Public Service Commission  
CAPITAL CIRCLE OFFICE CENTER • 2540 SHUMARD OAK BOULEVARD  
TALLAHASSEE, FLORIDA 32399-0850

-M-E-M-O-R-A-N-D-U-M-

**RE:** DOCKET NO. 030834-EI - REQUEST TO EXCLUDE OUTAGE EVENT FROM ANNUAL DISTRIBUTION SERVICE RELIABILITY REPORT FOR CALENDAR YEAR 2003, BY PROGRESS ENERGY FLORIDA, INC.

**ISSUE 1:** Should the Commission approve PEFI's amended petition to exclude from its 2003 Annual Distribution Service Reliability Report 9,220 service interruptions that occurred in PEFI's North Central Region on July 18, 2003?

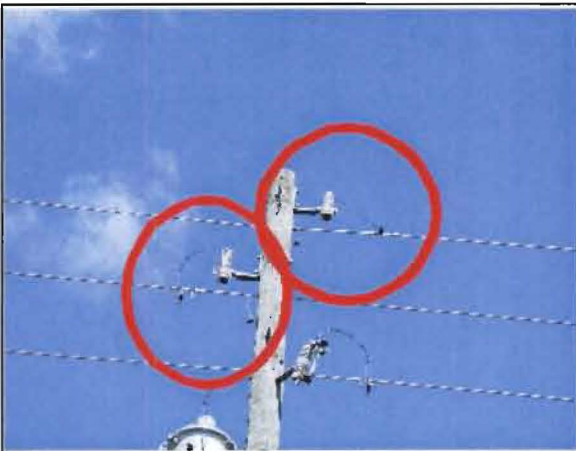
Velazquez No. 6: Next to pole 136062-045422 on Poinciana Pkwy approximately 2/10 of mile south of Lake Marion Creek Dr. Bottom of lightning arrester on top phase has failed. Note: The grounding conductor wraps around the highest insulator on the front side of the pole with the lightning arrester connection resting on top of the insulator. The grounding conductor-arrester connection can fall from its perch on the insulator and come in contact with the stinger wire of the top phase and cause a phase to ground fault on that phase.
